Access Compliance Report

Public Rights-of-Way

Intersection ID: 10019095	Main Street: FIREFLY_LN	Cross Street: N/A	Location: NE
ADA ID: 9C4296CCE723	Ramp Type: Perp	Initial Pass/Fail: Fail	Overall Compliance: No
Severity Score: 25			
Codes/Mitigation Info/Possible Solution		Field Measurements/Component Compliance

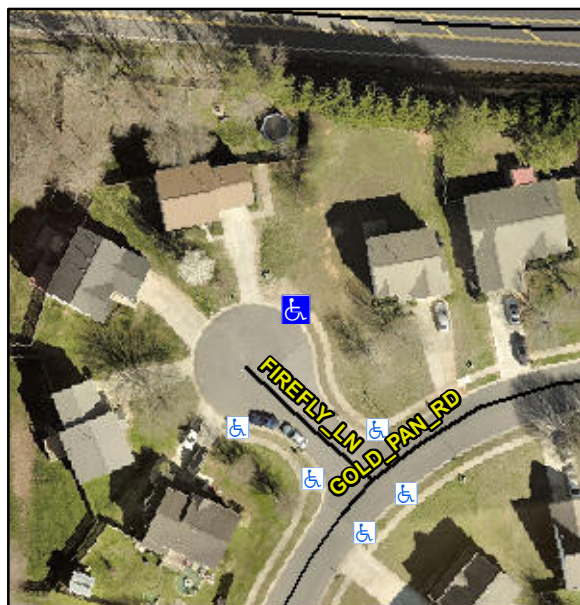
Not Found, R304.2.2

Compliance	Description	Data	Compliance	Description	Data
N/A	Ramp Length (in)	47.0	No	Ramp Slope (%)	16.9
Yes	Ramp Width (in)	48.5	Yes	Ramp XSlope (%)	1.7
N/A	Flare Type LT	N/A	N/A	Flare Type RT	N/A
N/A	Flare Slope LT (%)	N/A	N/A	Flare Slope RT (%)	N/A
N/A	Flare Traversable LT?	N/A	N/A	Flare Traversable RT?	N/A
N/A	Landing Length (in)	N/A	N/A	DWS Provided?	N/A
N/A	Landing Width (in)	N/A	N/A	DWS Contrast?	N/A
N/A	Landing Slope (%)	N/A	N/A	DWS Length (in)	N/A
N/A	Landing X Slope (%)	N/A	N/A	DWS Full Width?	N/A
N/A	Landing Curb? (Y/N)	N/A	N/A	DWS Offset (in)	N/A
N/A	Shared Landing?	N/A			
N/A	Gutter Ponding?	N/A	N/A	Gutter Slope (%)	N/A
N/A	Gutter Lip Ht (in)	N/A	N/A	Gutter X Slope (%)	N/A
N/A	Painted X Walk1?	No	N/A	Painted X Walk2?	N/A
	X Walk 1 Direction	To SW		X Walk 2 Direction	N/A
N/A	X Walk 1 Width (in)	N/A	N/A	X Walk 2 Width (in)	N/A
	X Walk 1 Slope (%)	3.4		X Walk 2 Slope (%)	N/A
	X Walk 1 X Slope (%)	1.3		X Walk 2 X Slope (%)	N/A

Remove & Replace Entire Ramp.
